Service Bulletin

PRELIMINARY INFORMATION

Subject: Intermittent Unwanted Trunk Opening While Vehicle is Parked

Models: 2010-2014 Buick LaCrosse
2011-2014 Buick Regal
2012-2014 Buick Verano
2011-2014 Chevrolet Cruze
2012-2014 Chevrolet Sonic (4 Door Sedan Only)
2013-2014 Chevrolet Malibu

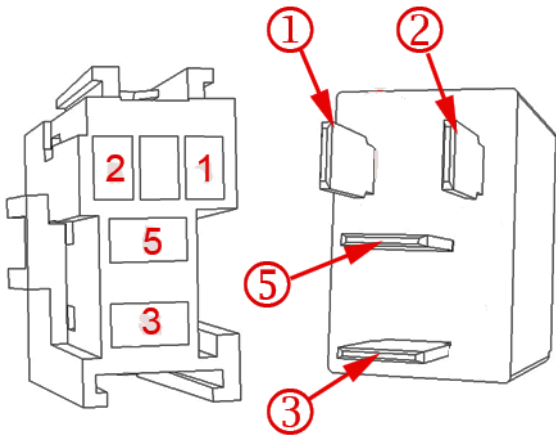
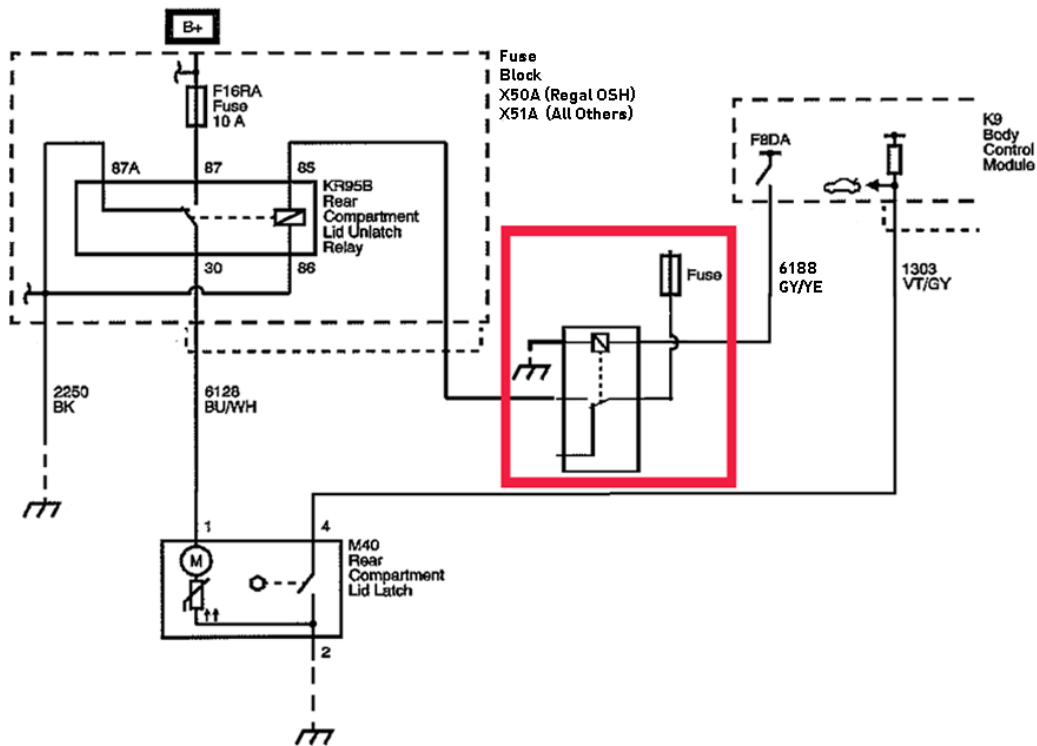
For Regal (2011 Oshawa Built (RPO OSH), 2012-2014) and Sonic

The rear compartment lid unlatch relay is part of the printed circuit board in the relay/fuse block and not serviceable separately. Installation of an external relay circuit to bypass the feed to the trunk release control will be required. Install the "Two Shot Relay" adjacent to the BCM and attach a tag to the relay and mark with "Two Shot Trunk Relay per Bulletin PI0924." For future diagnosis for an inoperative trunk release, this relay installation will be identified before a BCM is replaced.

1. Label the four leads of connector, P/N 12126045 as indicated below.
2. Connect the connector to the new relay, P/N 19119267.
3. Locate circuit 6188 (trunk release control) at the BCM following service information. Cut the wire and splice the BCM and relay side of the circuit as shown below.
4. Connect wire fused, unswitched power and ground as shown below.

- 1. BCM Circuit No. 6188
- 2. Ground
- 3. Relay Circuit No. 6188
- 5. Fused 12V Power
